THE CITY OF SAN DIEGO

# ADDENDUM TO A ENVIRONMENTAL IMPACT REPORT

Project No. 516820  
Addendum to EIR No. 233958  
SCH No.: 2011031074

SUBJECT: **BALBOA PARK PLAZA DE PANAMA PROJECT:** The following approvals are being requested in association with the project: AUTHORIZE A COOPERATION AGREEMENT BETWEEN THE CITY AND THE PLAZA DE PANAMA COMMITTEE, AUTHORIZE THE MAYOR TO AWARD A CONSTRUCTION CONTRACT FOR THE PROJECT, and AUTHORIZE FUNDING for Project. The Plaza de Panama Project, as previously approved proposes to remove vehicular access and parking from the Plaza de Panama, El Prado, Plaza de California, the Mall, and Pan American Road East and allow these areas to be used by pedestrians only. A new bridge, "Centennial Bridge," would connect the eastern end of Cabrillo Bridge to the western side of the Alcazar parking lot. From that point a new "Centennial Road" would traverse through the Alcazar parking lot exiting to the east, continue to the south past a new Organ Pavilion parking structure and then connect to Presidents Way. Additional parkland would be provided atop the new parking structure. A tram would provide service from the parking structure to the Plaza de Panama with

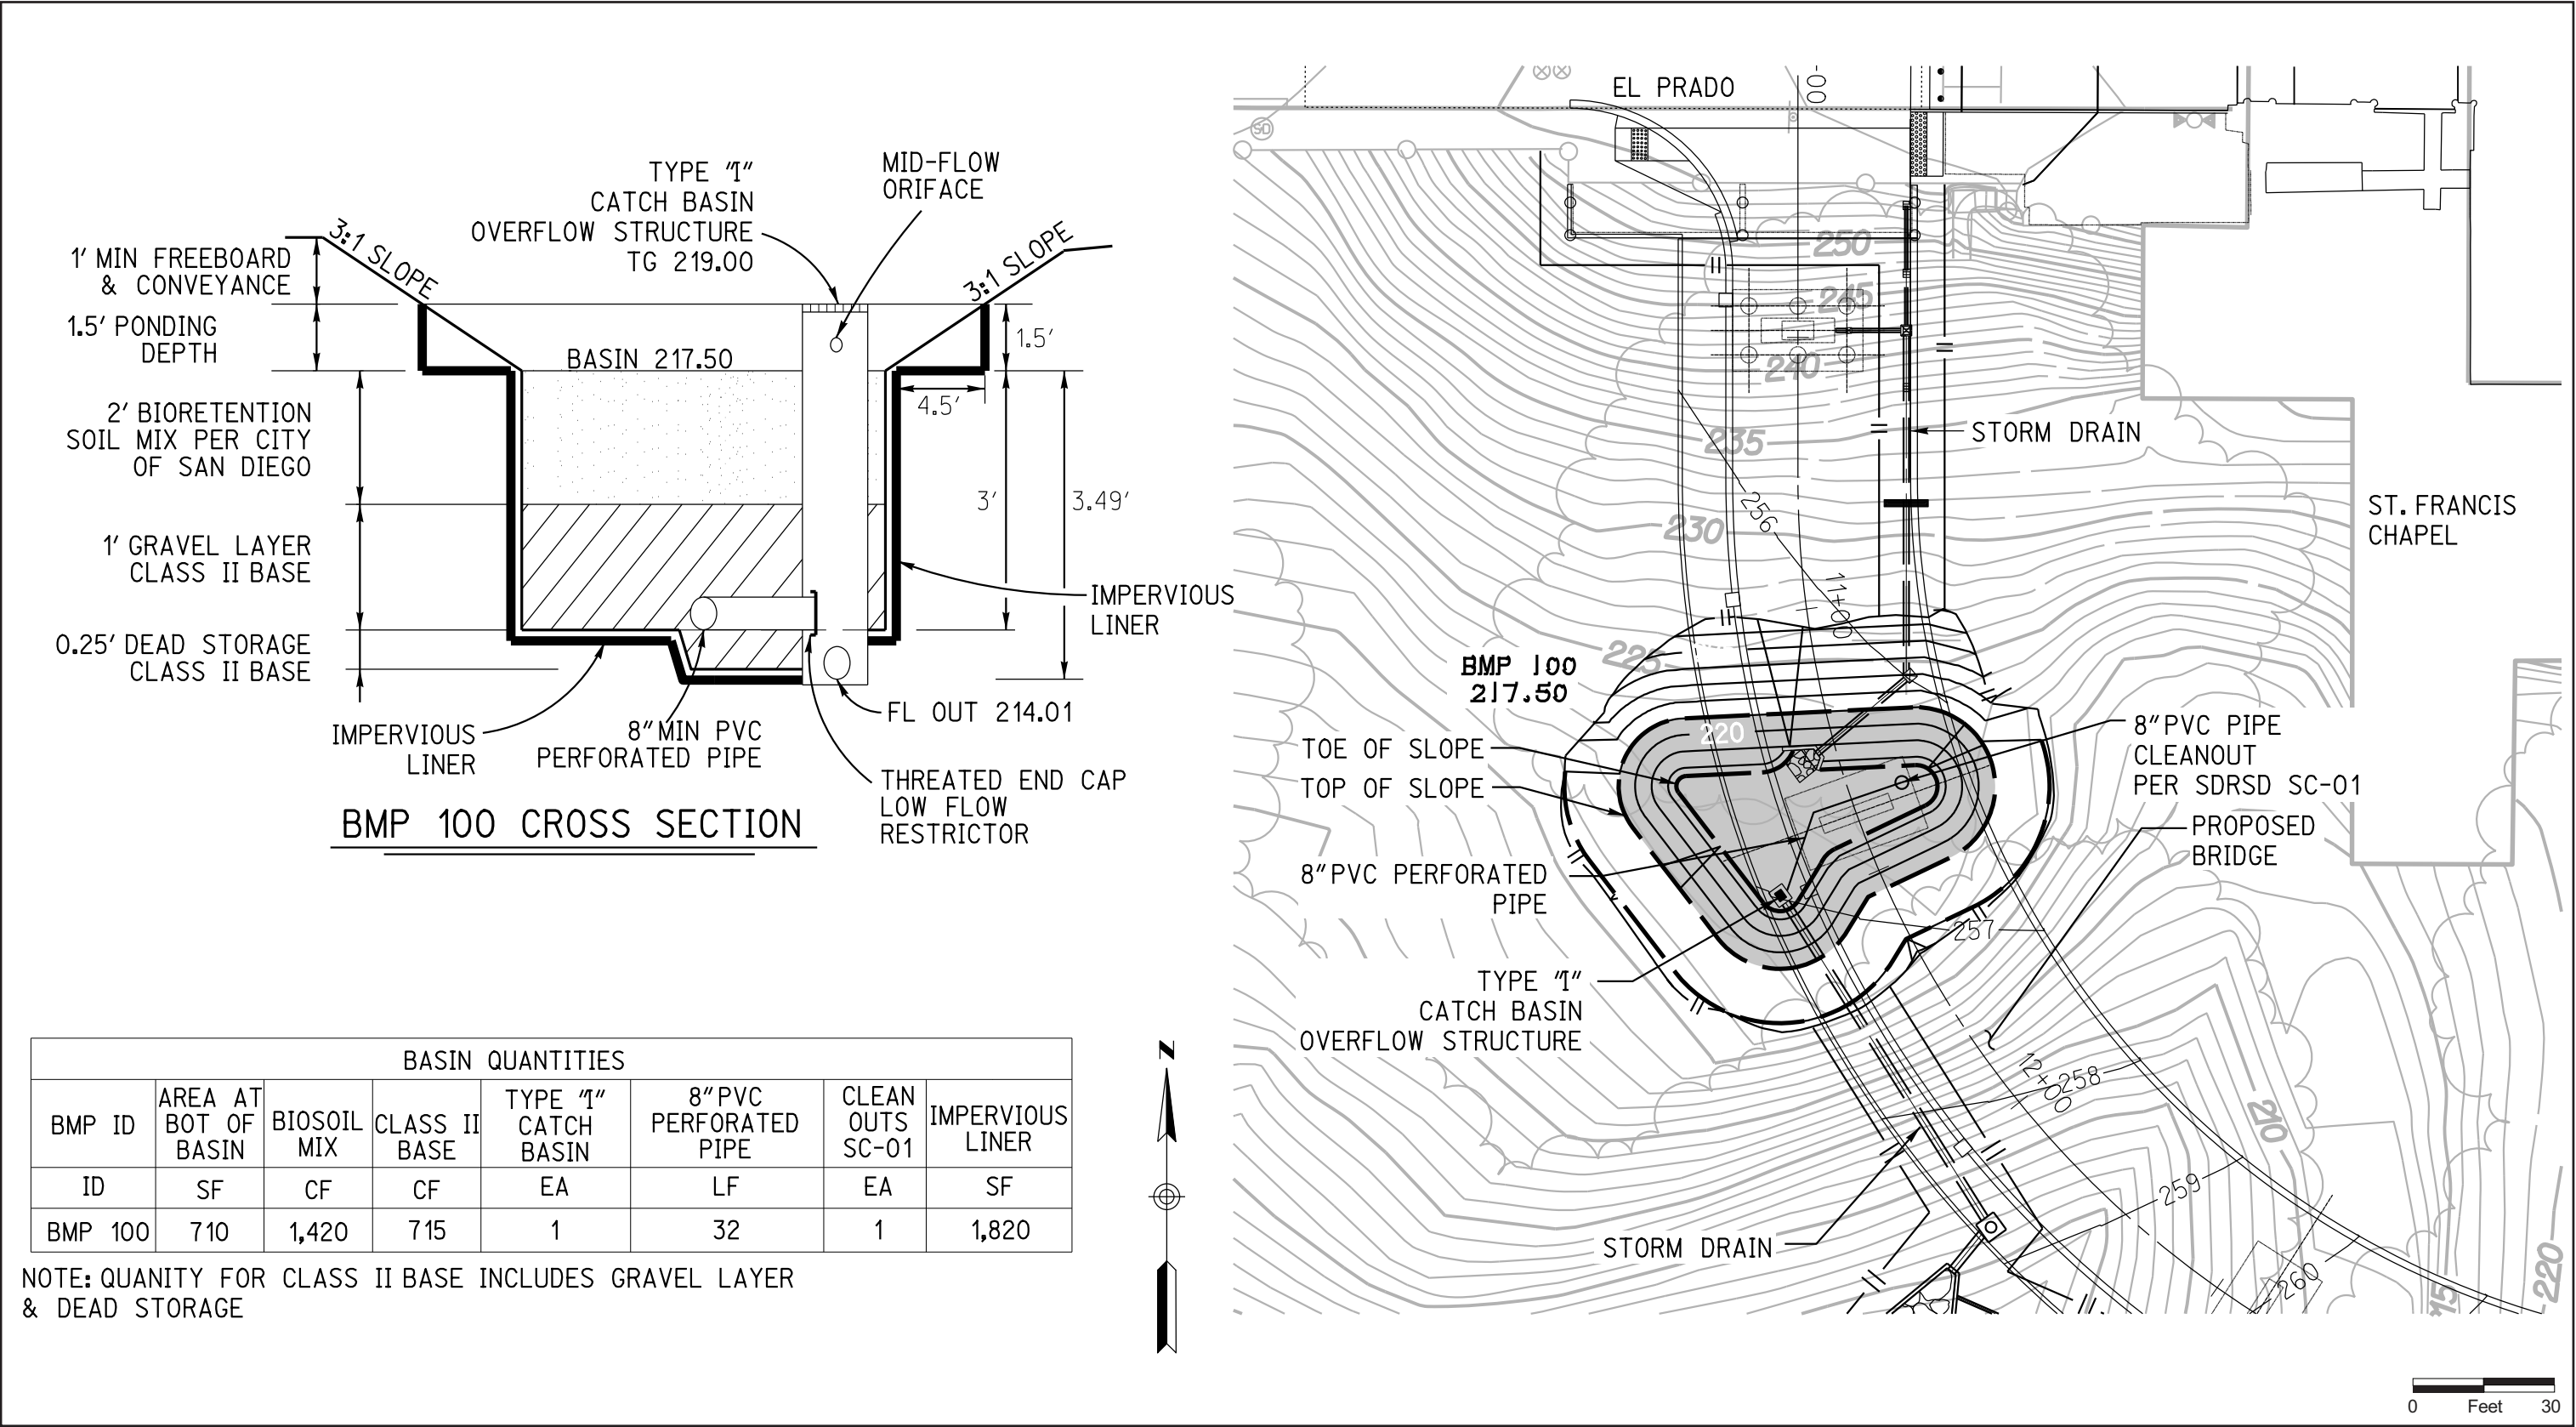
- **Centennial Bridge Supports** – Minor changes to the bents (columns) of the proposed Centennial Bridge are required to meet new California Department of Transportation (Caltrans) requirements. The number of bents has been reduced from six to four (Figure 1).

FIGURE 2  
BMP 100

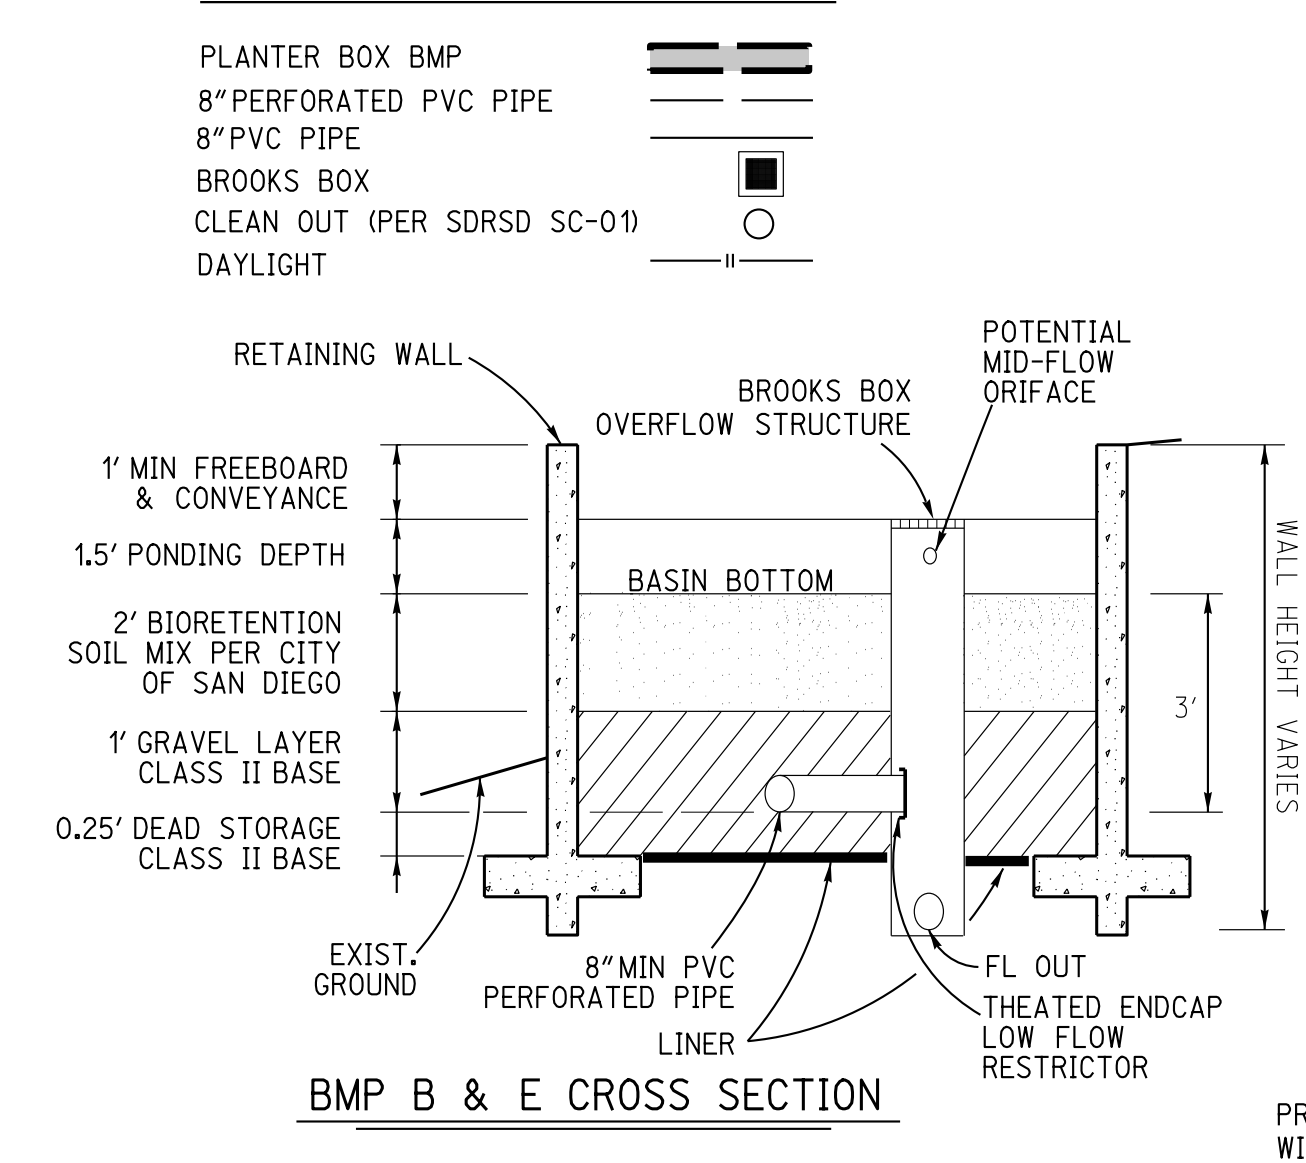
- **BMP A** – This basin, located underneath Centennial Bridge was included in the 2012 project. This basin would have a slightly smaller footprint as compared to what was shown in the original project (Figure 2).

FIGURE 3  
BMPs B & E

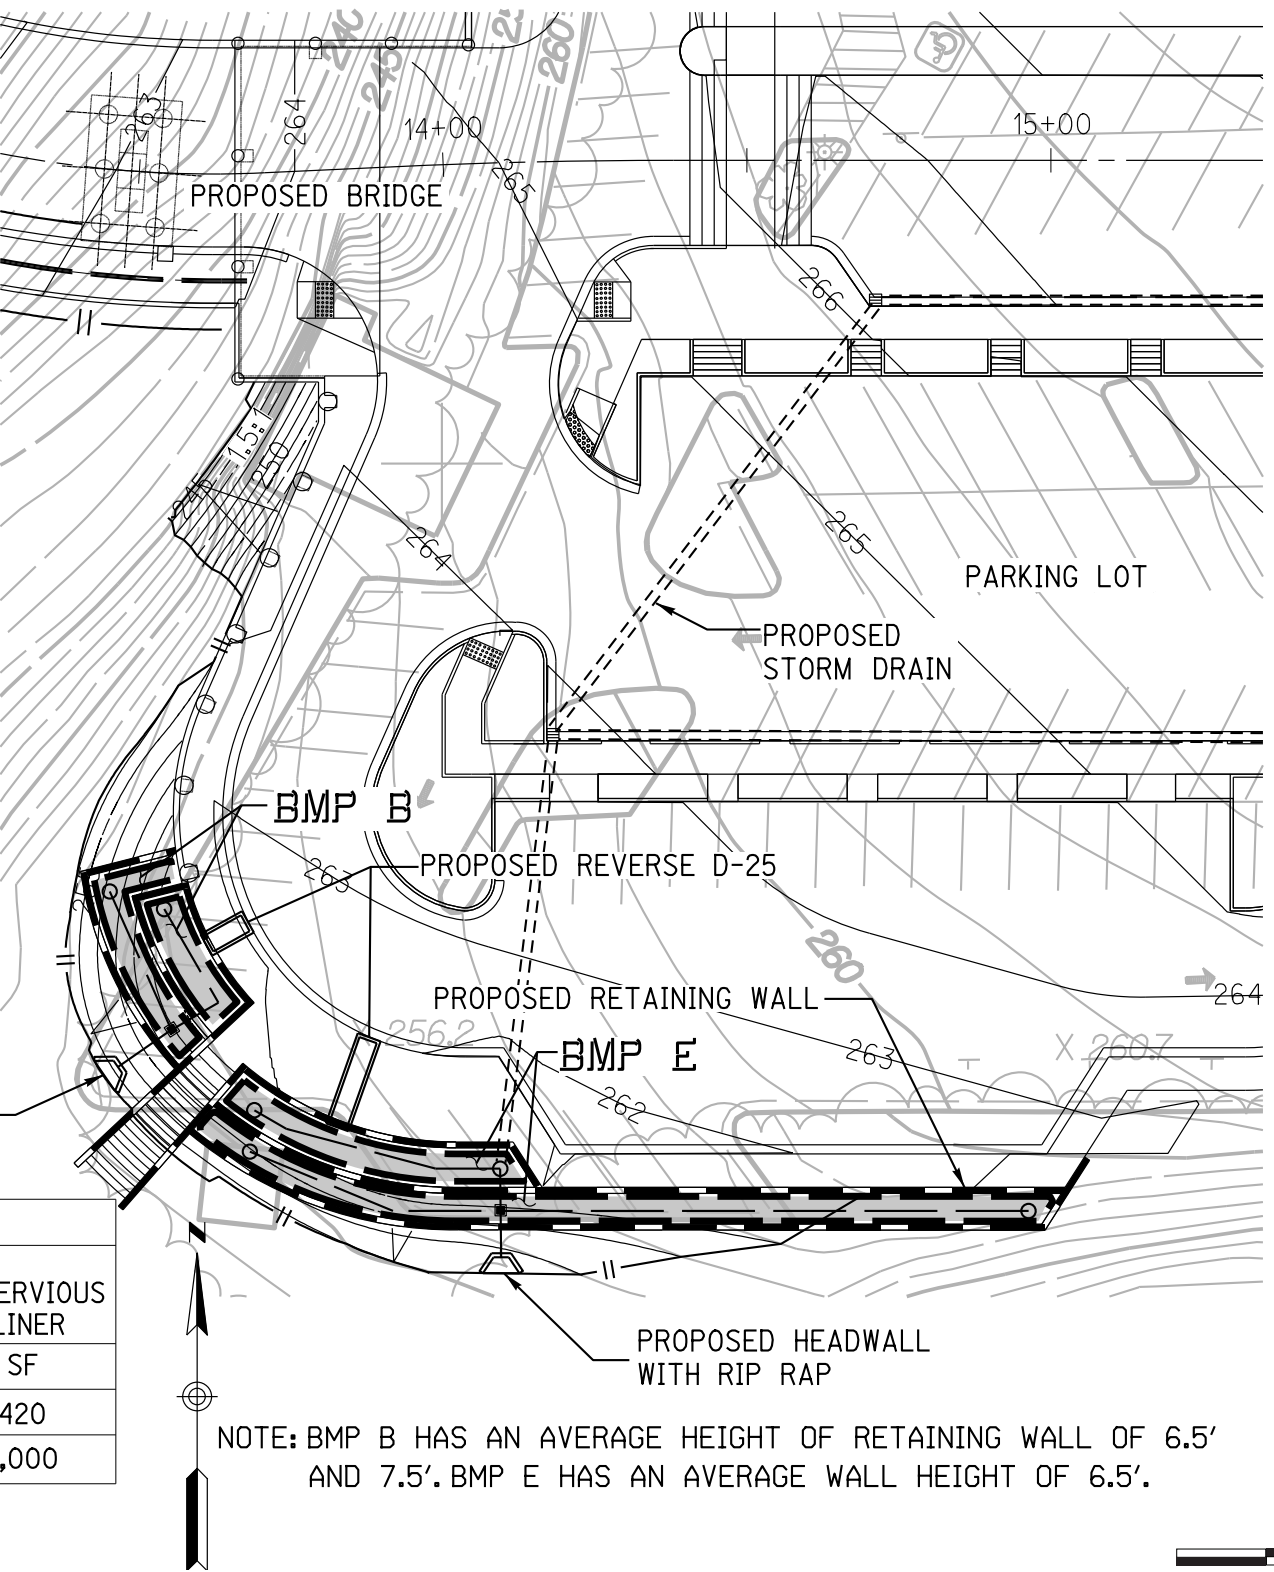
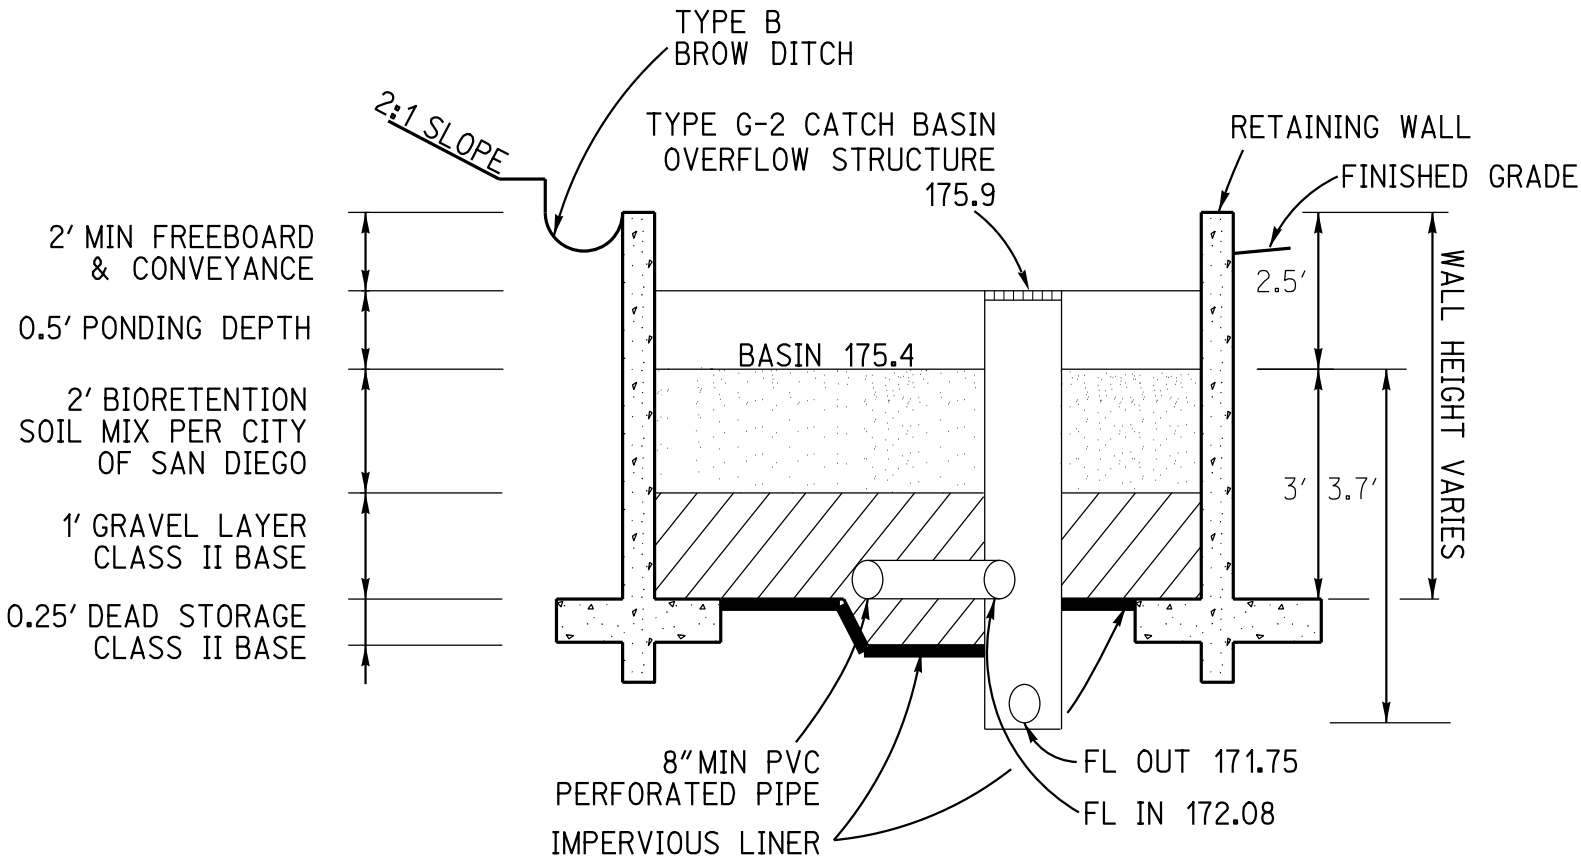
- **BMPs B & E** – These two basins would be co-located within the slope along the southwestern corner of the Alcazar parking lot (Figure 3). The current design would incorporate the BMPs into the existing retaining wall system identified in the 2012 EIR. The footings of the retaining walls would be buried and the walls would have a maximum exposure of 3.5 feet, which would be partially screened by existing vegetation. In any event, the 2012 project also included basins with smaller surface area and volume at this site that had retaining walls extending aboveground from 1-4 feet, so the change in the views of the retaining wall from the canyon is minimal or non-existent. Moreover, the retaining wall extending from BMP B to the Centennial Bridge as disclosed in the 2012 EIR is up to 15 feet high, and was not deemed a significant visual impact. The two retaining walls would be visible from the archery range canyon, Palm Canyon, and the International Cottages. The walls would not be visible from the Alcazar parking lot. The bottom of these basins would consist of soil that would be vegetated. The interior walls of the basins would extend above the basin bottoms by no more than 2.5 feet and would be partially screened by the grasses and bushes planted in the basin bottoms.

NOTE: BMP B HAS AN AVERAGE HEIGHT OF RETAINING WALL OF 6.5' AND 7.5'. BMP E HAS AN AVERAGE WALL HEIGHT OF 6.5'.

FIGURE 5  
BMP U

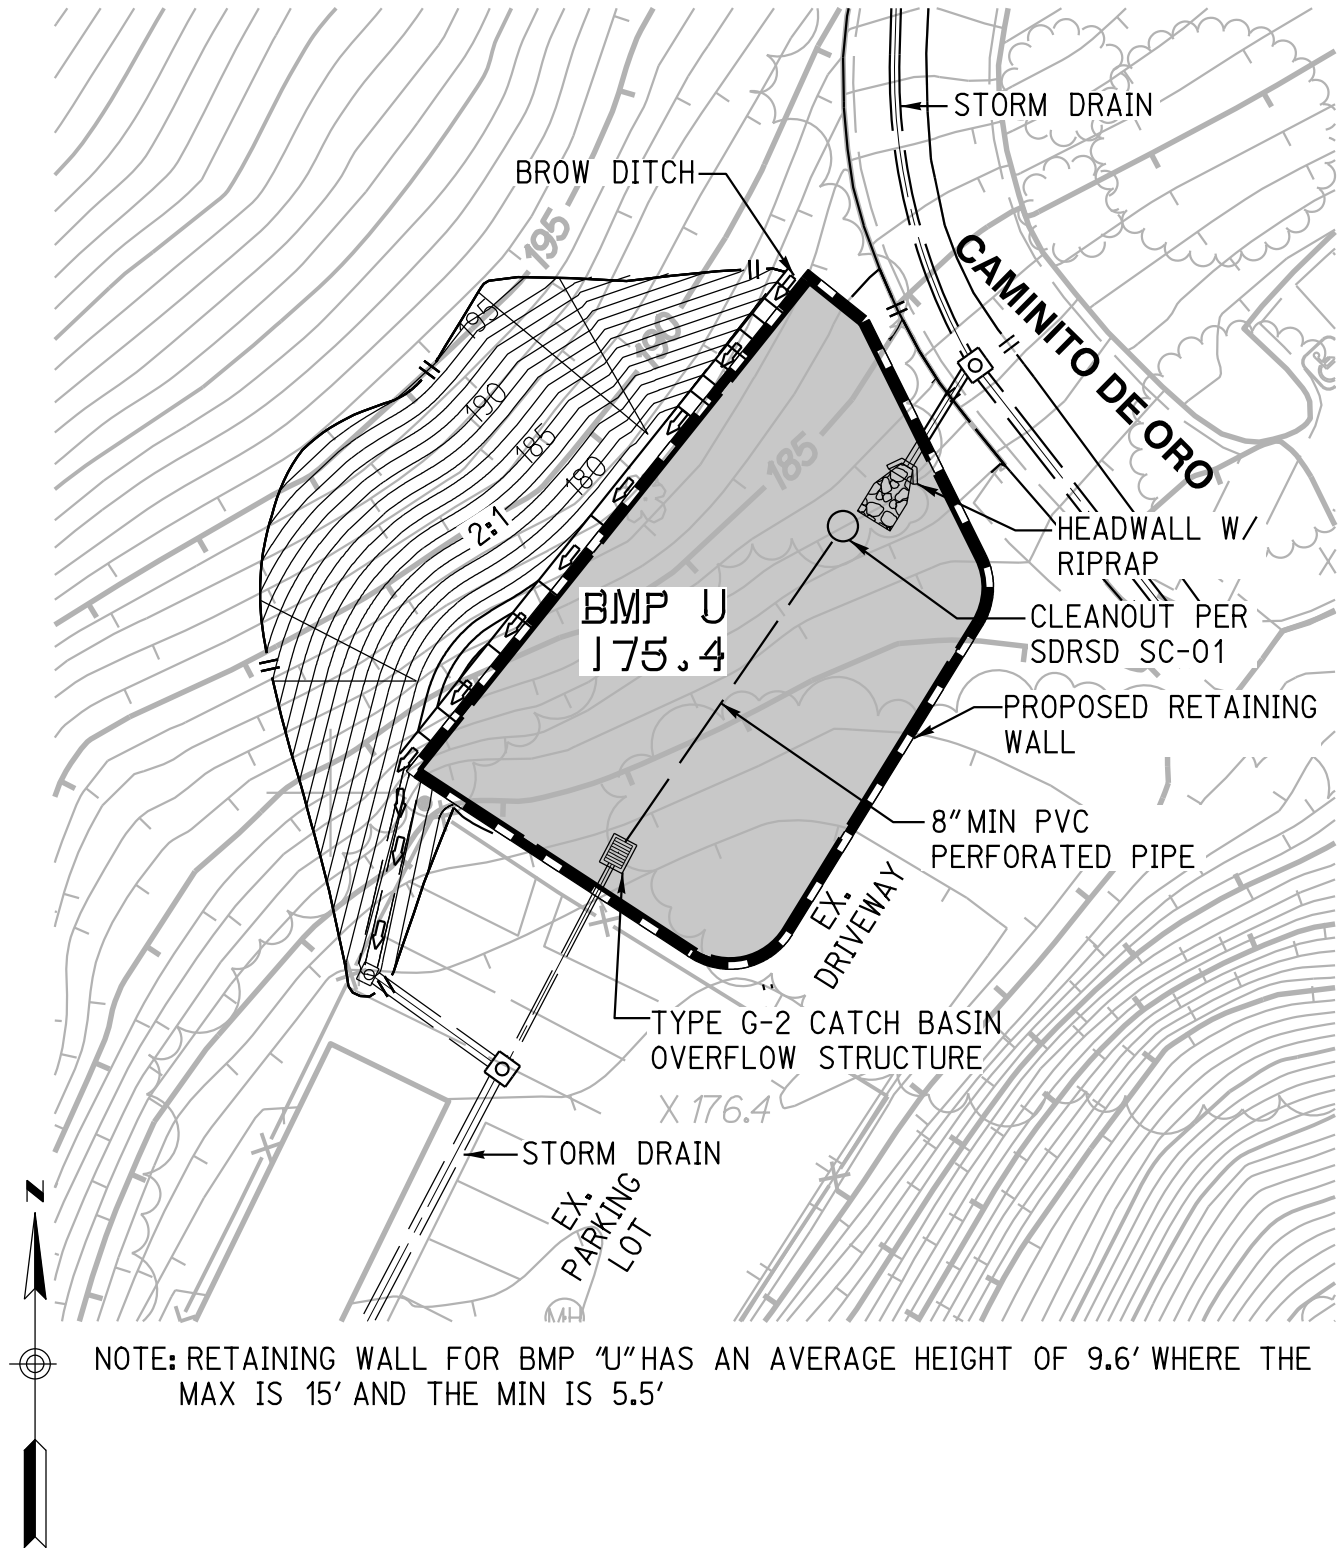
- **BMP U** – This basin (Figure 5) would be located within an off-site improvement area located within a previously disturbed area in Gold Gulch, adjacent to Caminito de Oro and inside the fenced Park and Recreation Department maintenance yard (tram yard). This improvement would be the only BMP located outside the grading footprint of the 2012 project.

NOTE: RETAINING WALL FOR BMP 'U' HAS AN AVERAGE HEIGHT OF 9.6' WHERE THE MAX IS 15' AND THE MIN IS 5.5'
